Figure correction in service manuals

The unbalanced connection diagram in the Test Procedures section of the Panaray (502) service manual, P/N 170310, and in the 402/802 II service manual, P/N 174785, is incorrect. **Figure 19 on page 33** of the 502 service manual and **Figure 24 on page 23** in the 402/802 II service manual should be changed as follows (only a partial figure is shown):

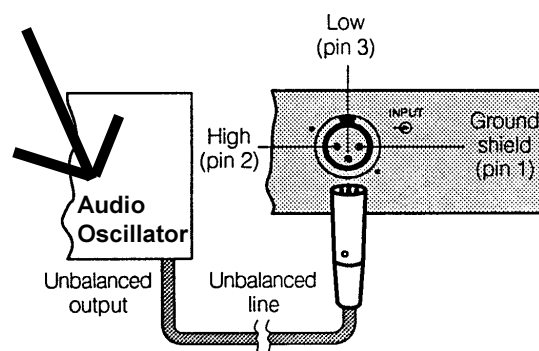
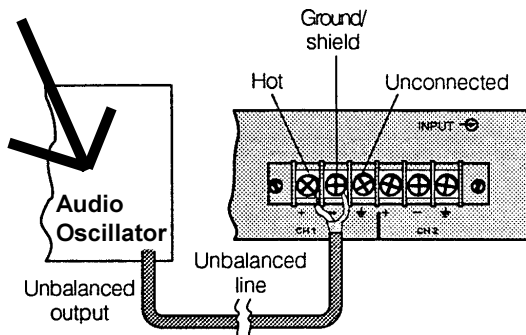
The input device was incorrectly identified as an amplifier. It should be a signal generator or audio oscillator.
